**NUMBER: 230120052.01****MODEL: Karma****TITLE: PTC Heater Thermostat****PRIORITY:****If vehicle exhibits the issue****APPLICABILITY:****All variants****MARKET REGION:****U.S., Canada, Europe, Middle East, and China****DATE: December 19, 2012****MODEL YEAR: 2012 - 2013****PURPOSE:**

TITLE: PTC Heater Thermostat

Figure 1A. Shown with RH cross brace removed.

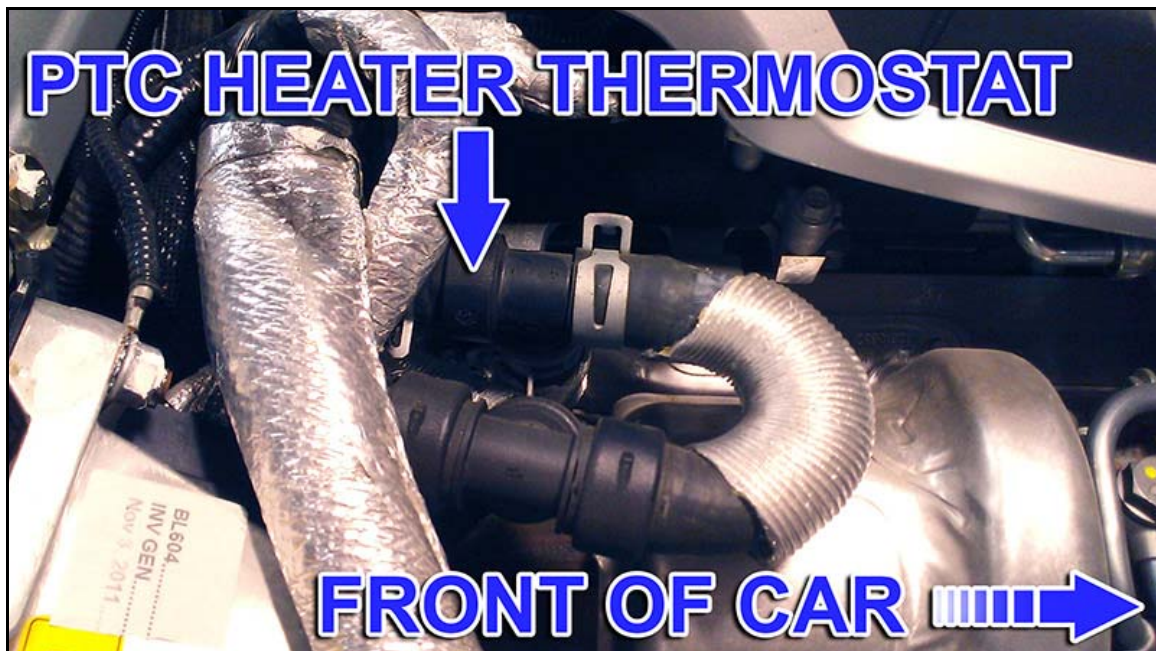
1.2. Locate the thermostatic check valve "T" located in front of the passenger side bulkhead (near turbocharger).

1.3. Clamp off each hose going into the "T" using suitable clamping devices to minimize coolant loss.

1.4. Take note of the tabs on each spring loaded hose clamp's orientation. Remove and discard spring loaded hose clamps followed by removing the 40° C thermostat "T" check valve.

1.5. Install replacement 65° C thermostat "T" (PN:C131133101001) using new hose clamps.
